Vogtle Electric Generating Plant- Units 1&2
Systematic Risk-Informed Assessment of Debris Technical Report SNC Response to
NRC Request for Additional Information (RAIs #11-14)

SNC Response to NRC Request for Additional Information (RAIs)

Figure 11-1: Example of weld that does not monotonically increase with break size

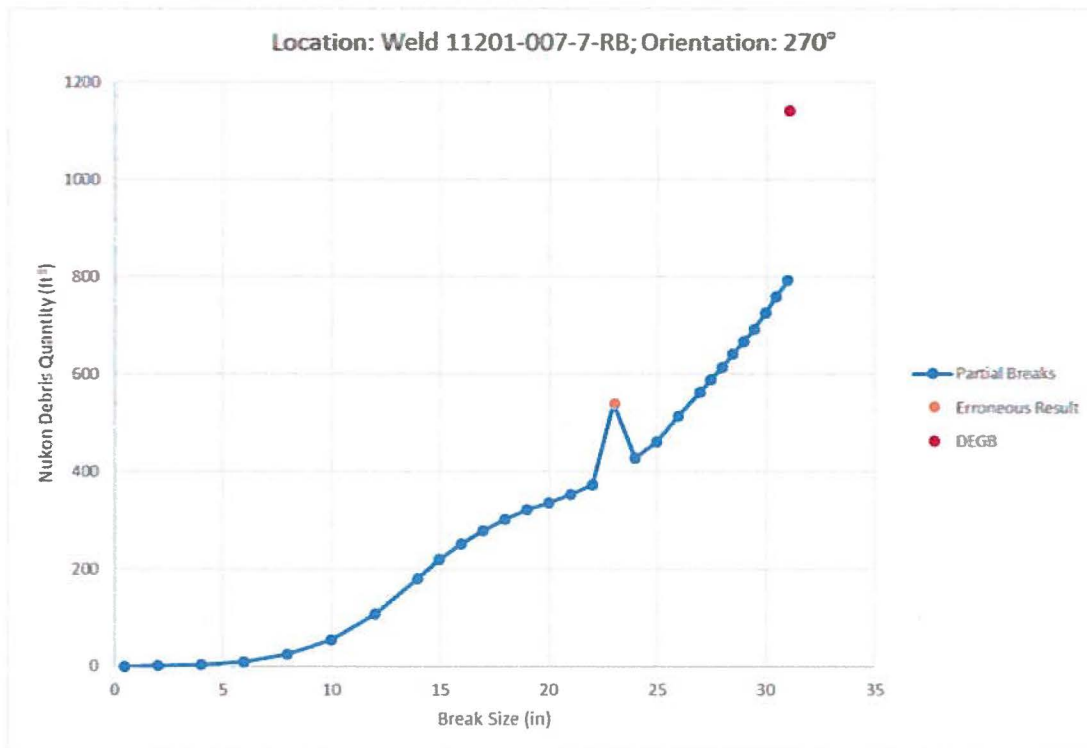
- a. Please describe quality assurance procedures taken (e.g., validation and verification processes) to ensure the NARWHAL software produces high fidelity results.
- b. Please describe tests of BADGER software performed to verify that the total debris monotonically increases with break size.

When the BADGER results database for Vogtle was evaluated in more detail, it was discovered that in some cases the debris quantity does not always monotonically increase with break size (see example in Figure 11-1).

For a given break location and break orientation, it is not physically possible for a larger break to have a smaller debris quantity. Therefore, this is an erroneous result in the calculation.

The potentially significant erroneous results for the 47 ZOIs were corrected in a modified BADGER database by conservatively using the debris quantity for the next larger break size at

the same location and orientation. A sensitivity case was run in NARWHAL, which showed that the variations for these debris quantities had no effect on the conditional failure probabilities.

Figure 12-1: Maximum fiber on the RHR Strainer

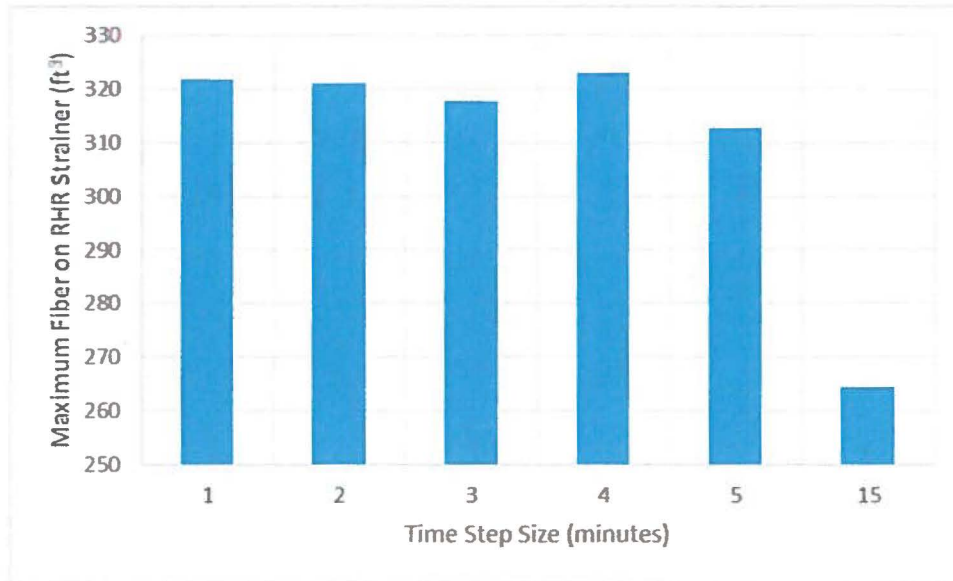
Please describe the time step(s) used in executing the marching algorithms and whether those time steps are sufficient to ensure convergence of the results to capture the pertinent GSI-191 phenomena modeled properly (e.g., time evolution of head loss and in-core fiber penetration).

The following figures show the results from the equipment configuration with all pumps running for the break that results in the most fiber on the RHR strainer (DEGB at weld 11201-004-6-RB on the hot leg in Loop 4). Figure 12-1 and Figure 12-2 show the fiber accumulation on the RHR and CS strainers. As shown, the results have very little variability for the smaller time-step sizes, but are significantly different for the 15-minute time-step size.
